APPLICATION FOR CONSTRUCTION PERMIT
FOR ON-SITE SEWAGE MANAGEMENT SYSTEM

Permit Number: S-069-2000-02320

Property Address: 4815 THUNDER RIVER DRIVE
GAINESVILLE, GA 30501

LEVEL III SOILS MAP

SKETCH IS APPROXIMATE, NOT TO SCALE

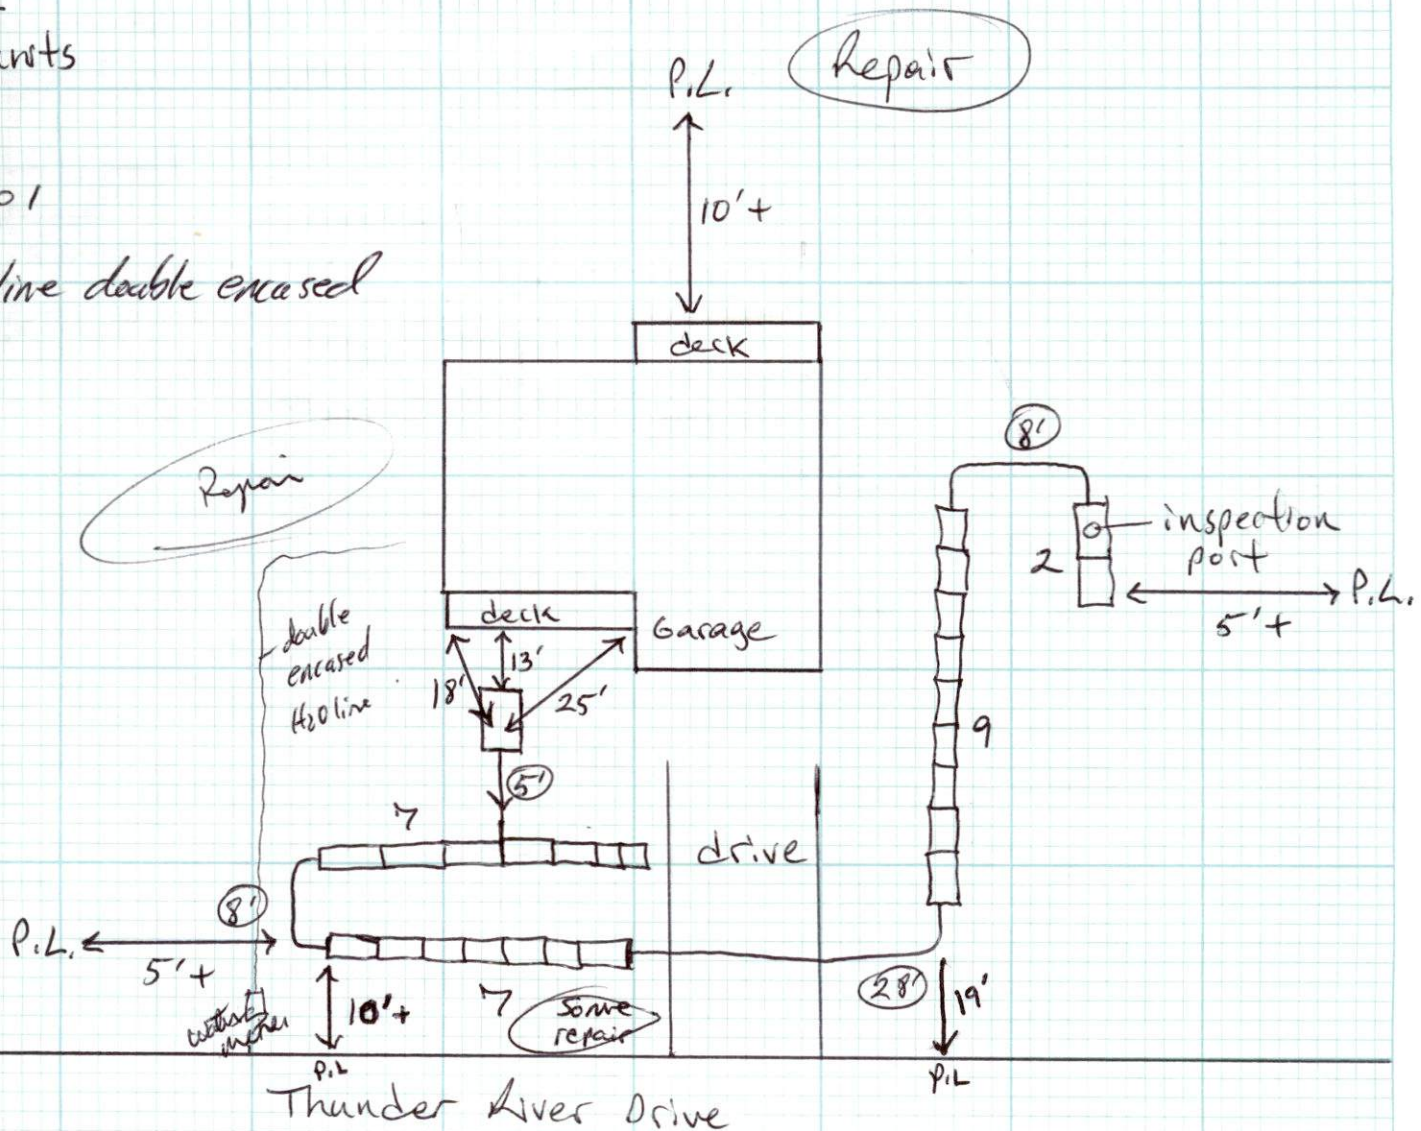
Nix 1000 compartmented
zabel filter

Infiltrator 156.25' total
avg TD: 48"

$$\begin{array}{r} 7 \\ 7 \\ 9 \\ + 2 \\ \hline 25 \text{ units} \end{array} \quad \begin{array}{r} 25 \\ \times 6.25 \\ \hline 156.25 \text{ total feet} \end{array}$$

Water line double encased

HALL COUNTY BOARD OF HEALTH
GAINESVILLE, GA 30503
APPLICATION FOR CONSTRUCTION PERMIT
FOR ON-SITE SEWAGE MANAGEMENT SYSTEM

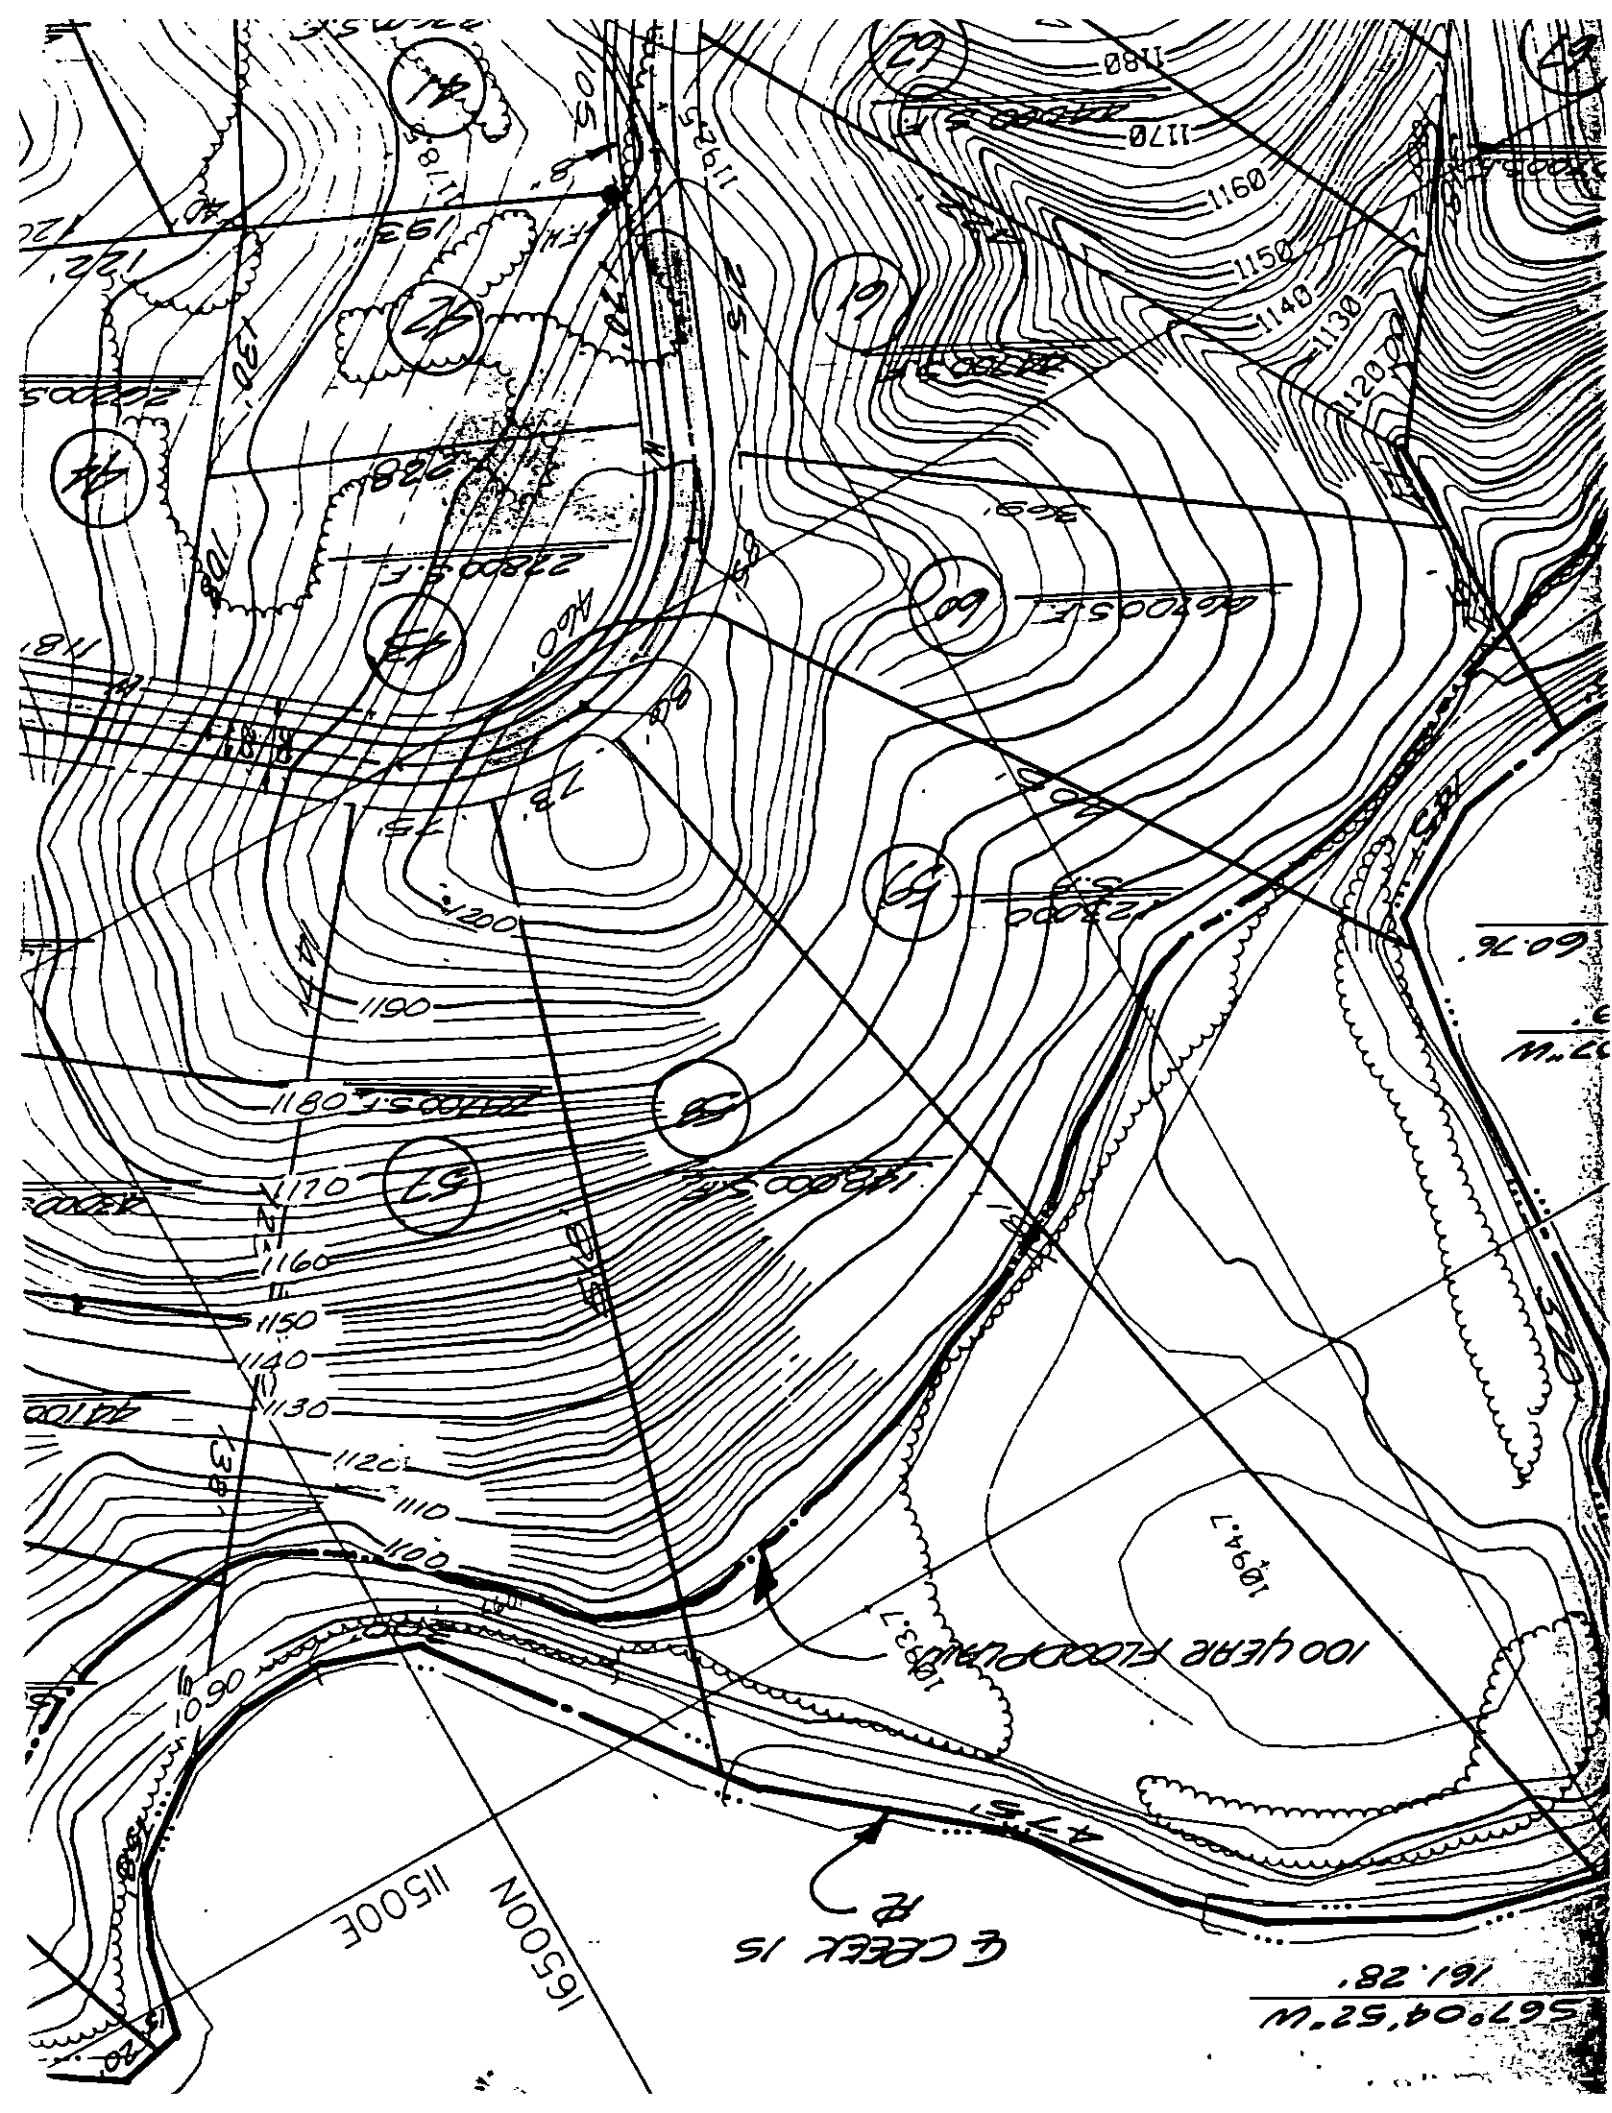
Split system /

Full length system

264' gravel / pipe

system in front and right side
of lot - hard pipe under
drive.

- place system shallow due to rock
- Stay out of fill w/ system

Repair may be ~~dig~~ dig another ^{due to} rock / slope.
